**Halton District School Board
RFT 25-061 School Renovation Project - Paul A Fisher PS**

Addendum No. 3

PROJECT NO. 24131
HOSSACK ARCHITECTURE

ADDENDUM NO. 3

SCALE	PROJECT
1 : 100	
DATE	241222
DECEMBER 2024	
DRAWN	DRAWING
VW / KL / SL	
CHECKED	M03
VK / GR	
PRINT DATE	2024-12-10 11:47:39 AM

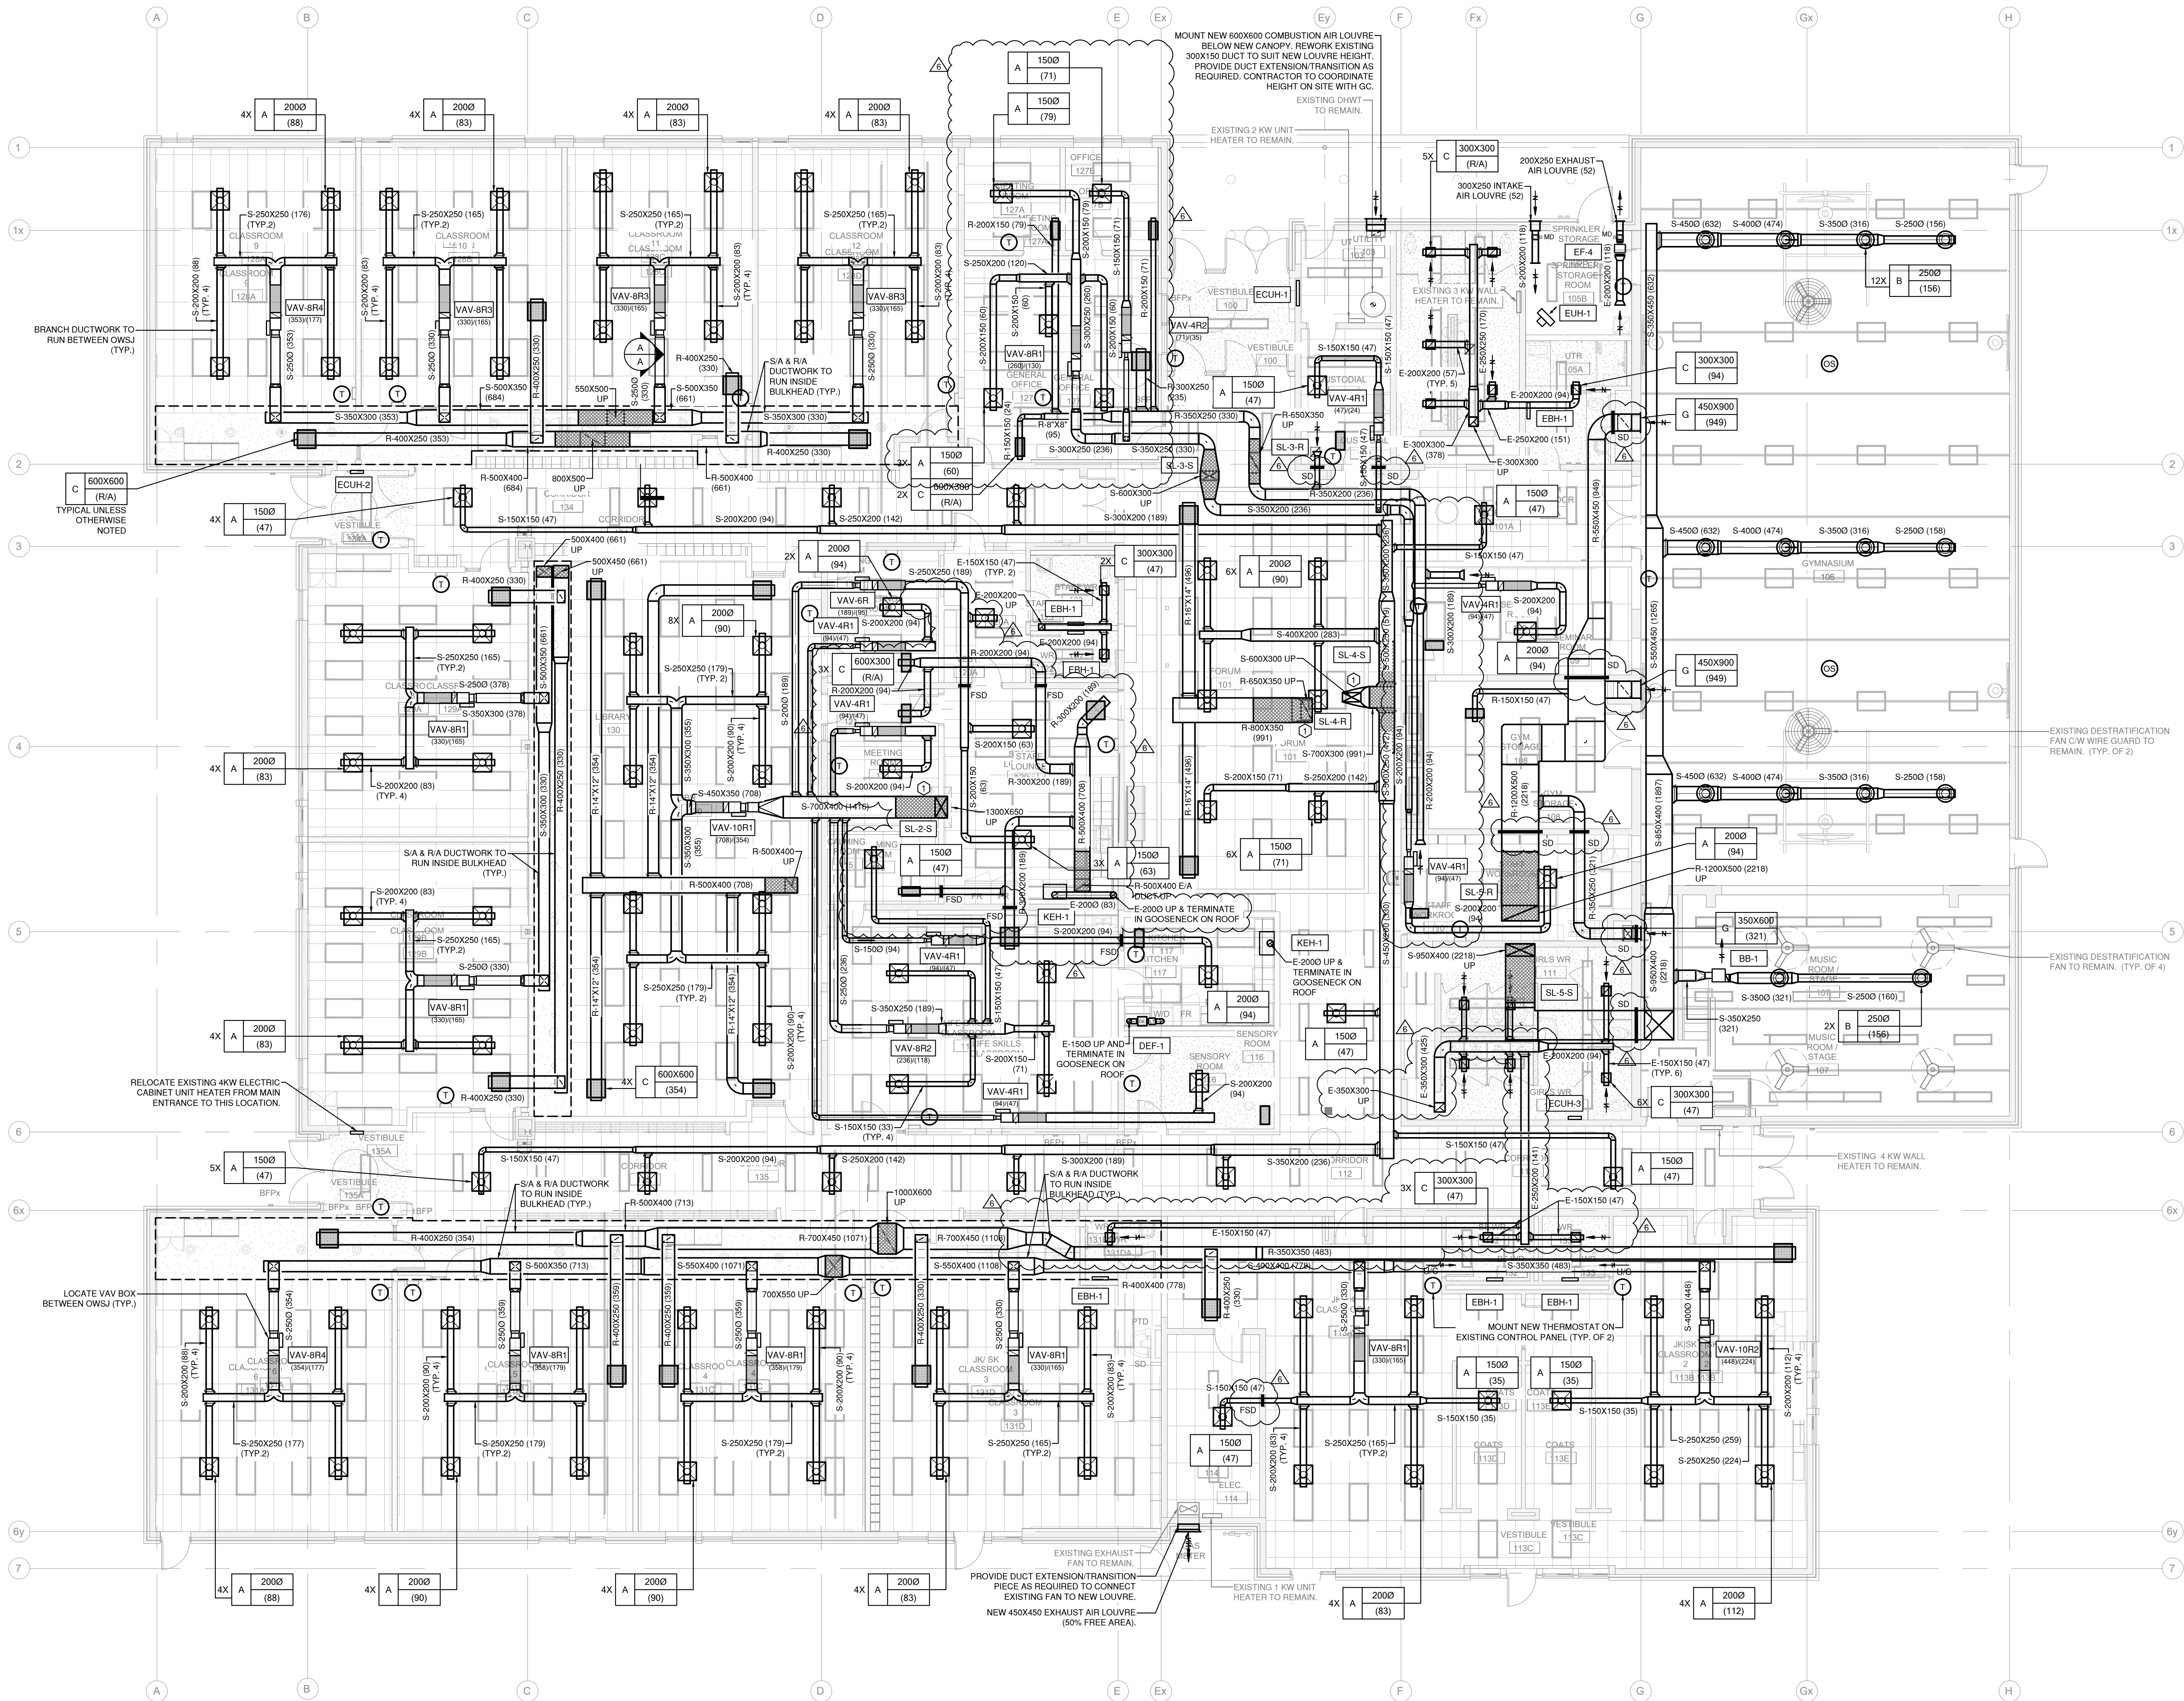
- .1 Refer to drawing M-03: NEW WORK FLOOR PLAN - HVAC and include for the following changes:
 - .1 Revise ductwork size for exhaust fan EF-2 as indicated.
 - .2 Include for ductwork and type 'C' grille for washroom WR 131DA.
 - .3 Revise duct and diffuser/grille layout for Calming Room 115 as indicated.
 - .4 Revise duct and diffusers/grilles layout for General Office 127, Meeting Room 127A and Office 127B as indicated.
 - .5 Revise ductwork for Staff Workroom 110 as indicated.
 - .6 Revise duct and diffusers/grilles layout for Vestibule 120A, Staff Lounge 120, Meeting Room 119, and Meeting Room 121 as indicated.

- ① PROVIDE 16G DUCT TRANSITION BETWEEN SILENCER AND RTU CONNECTION.

SCALE	PROJECT
1 : 100	24122
DATE	DRAWING
DECEMBER 2024	M05
DRAWN	CHECKED
VW / KL / SL	VK / GR
PRINT DATE	2024-12-10 11:47:39 AM

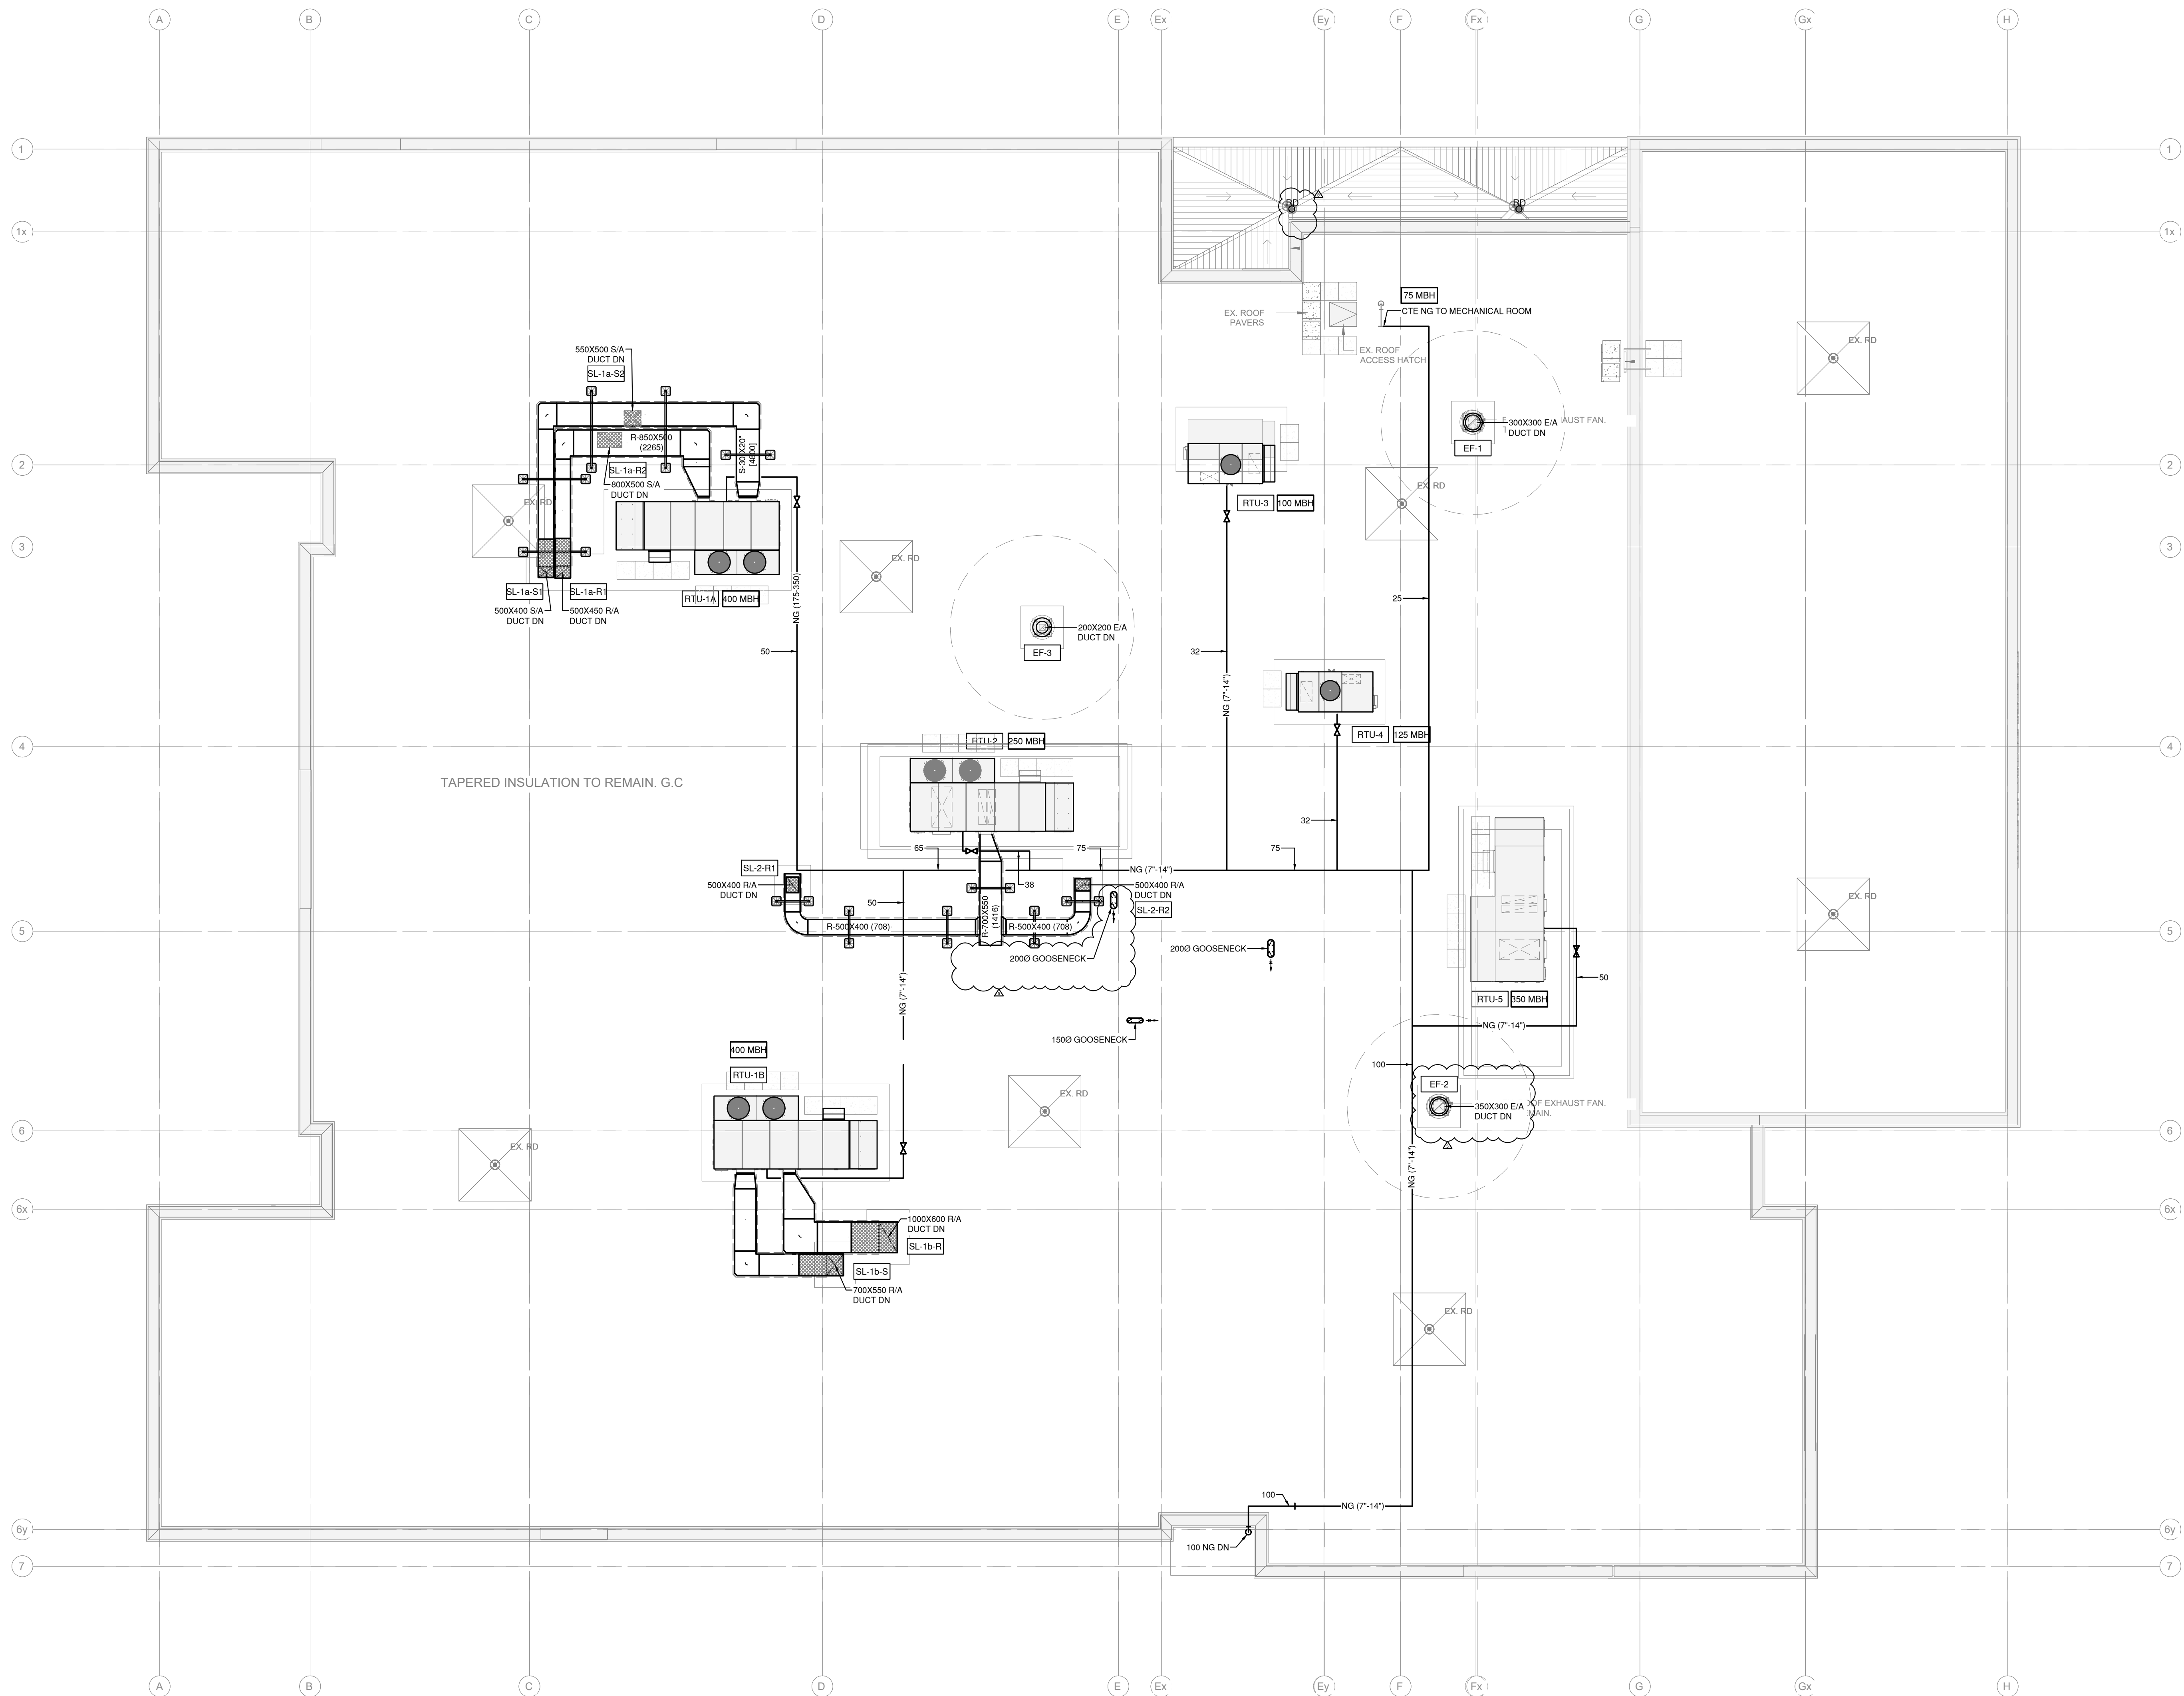
- .1 Refer to drawing M-05: NEW WORK ROOF PLAN - MECHANICAL and include for the following changes:
 - .1 Revise duct size for exhaust fan EF-2 as indicated.
 - .2 Revise range hood exhaust gooseneck termination location as indicated.
 - .3 Provide new roof drain provided as per permit comments.

SCALE 1:100	PROJECT 24122
DATE DECEMBER 2024	DRAWING M07
DRAWN VW / KL / SL	
CHECKED VK / GR	
PRINT DATE 2024-12-10 11:47:39 AM

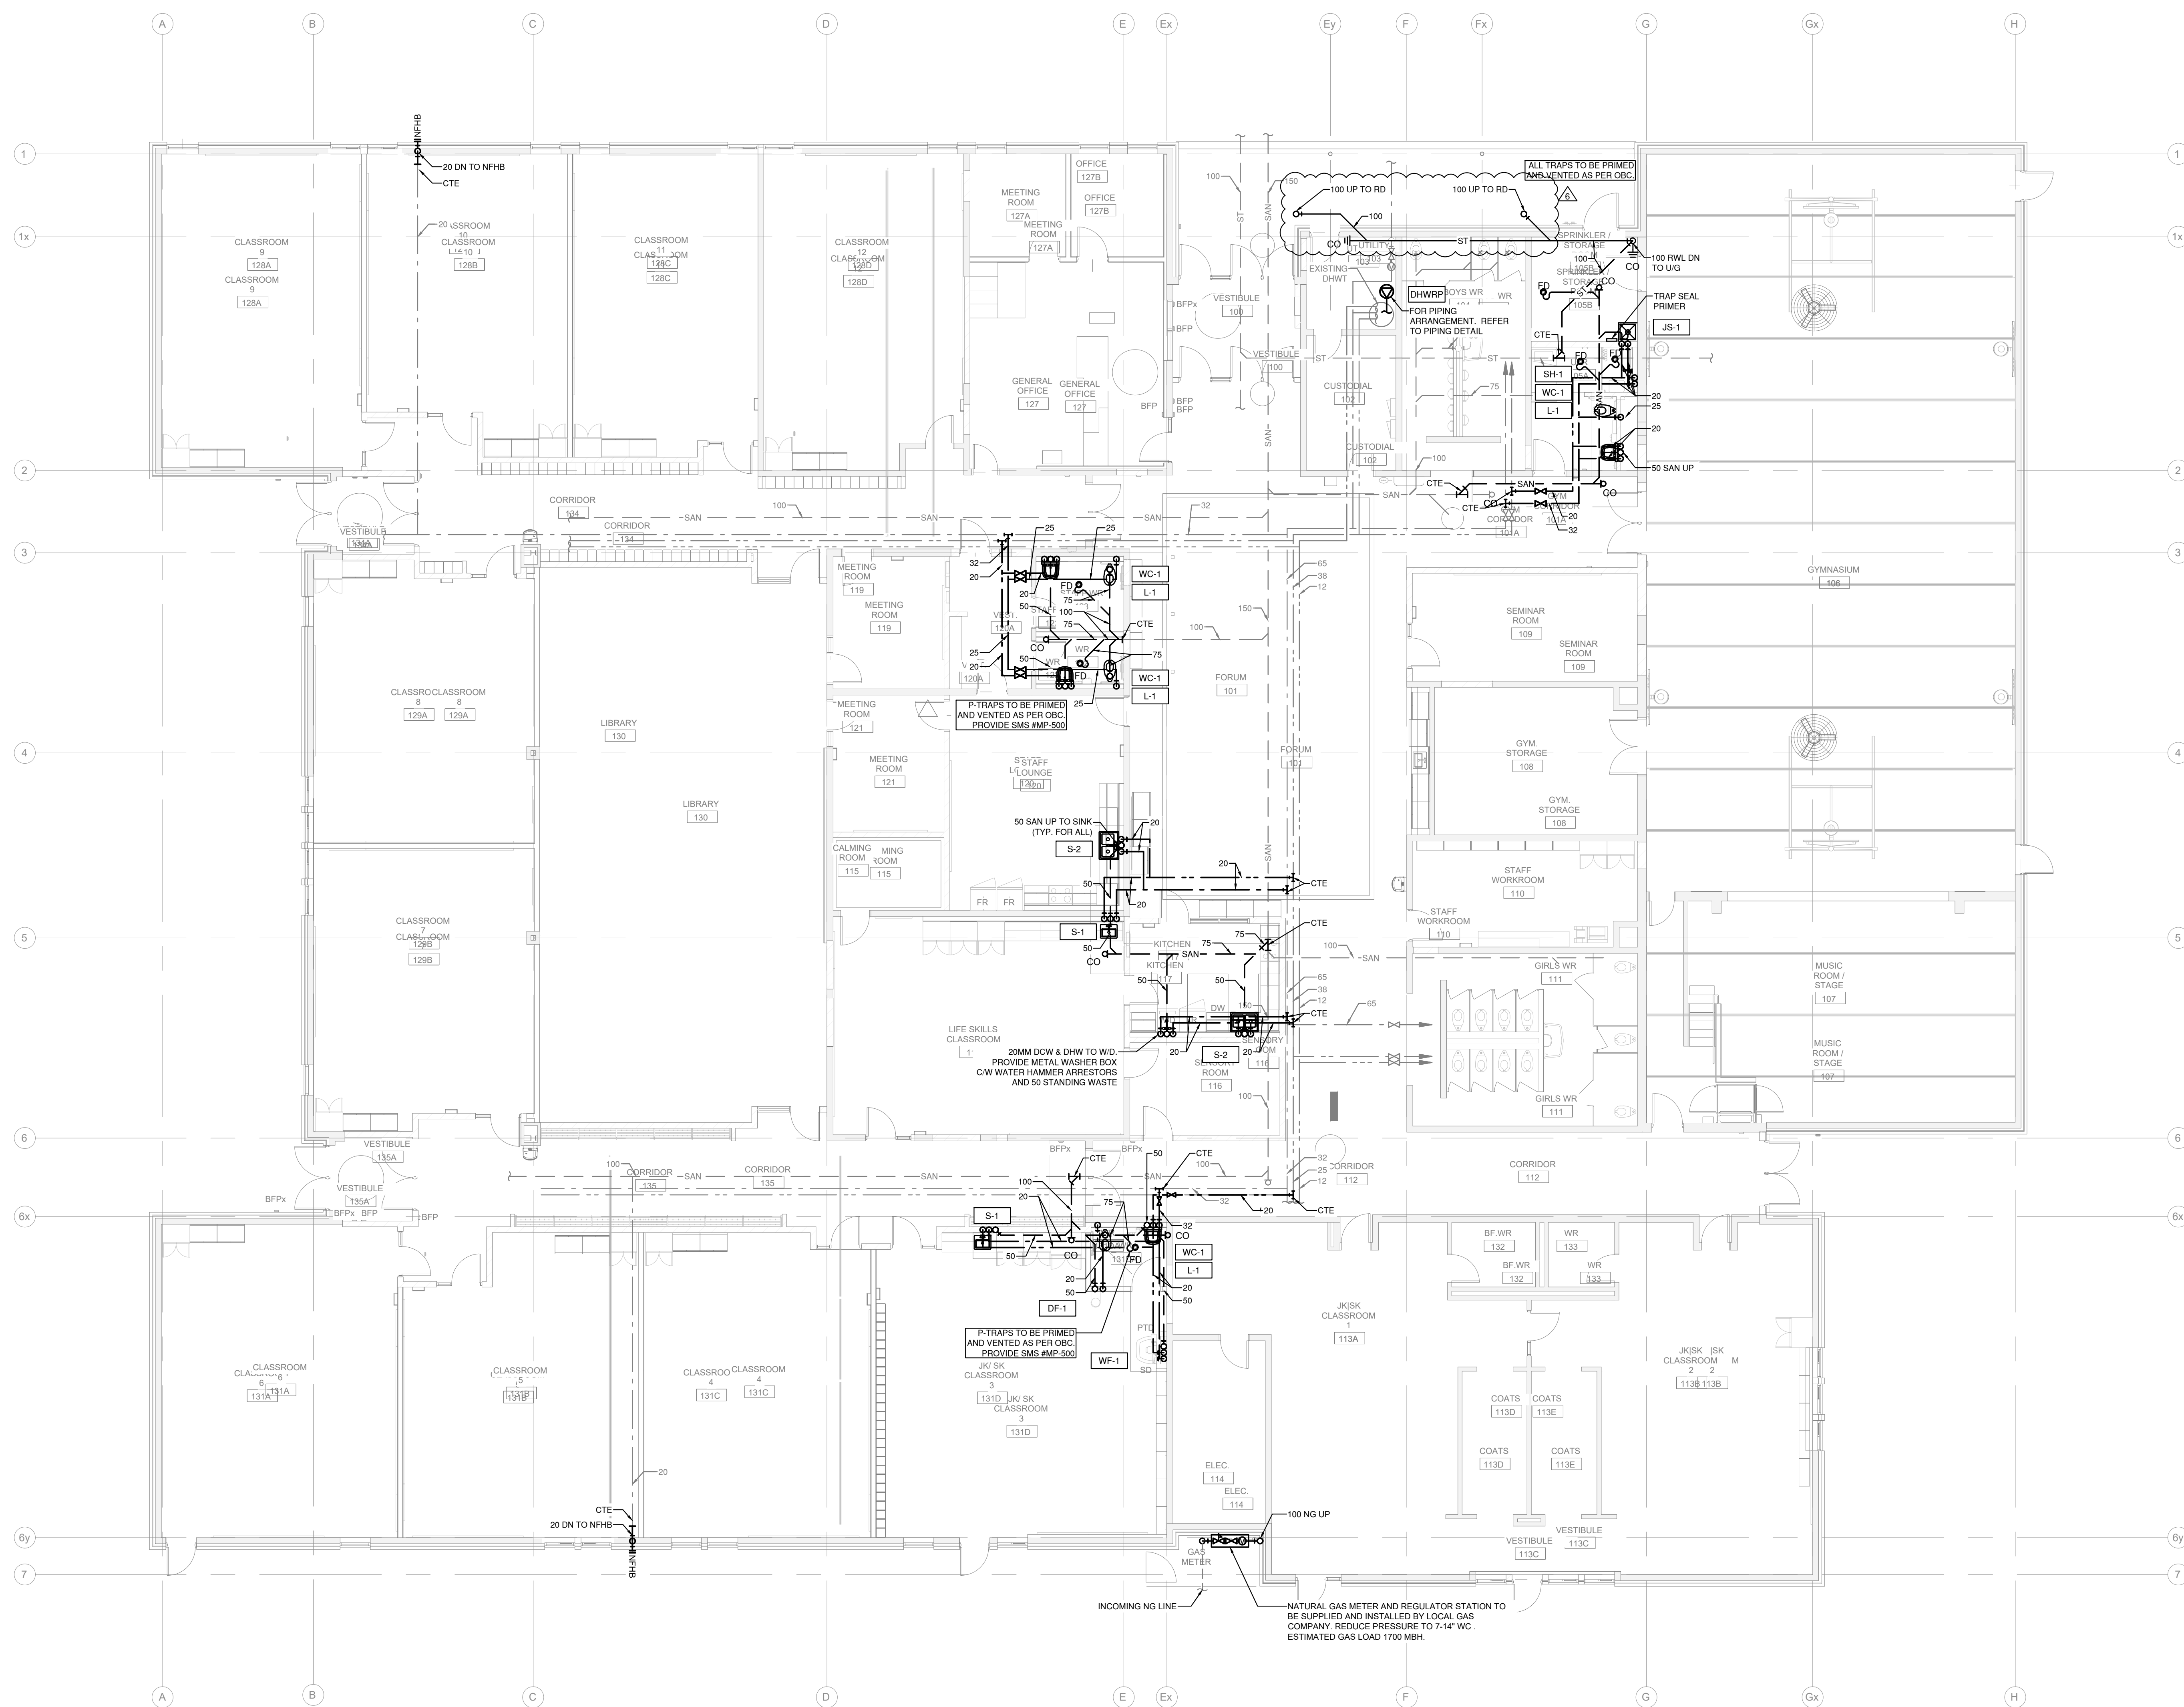
- .1 Refer to drawing M-07: NEW WORK FLOOR PLAN - PLUMBING and include for the following changes:
 - .1 Provide storm piping as indicated for new roof drain above.
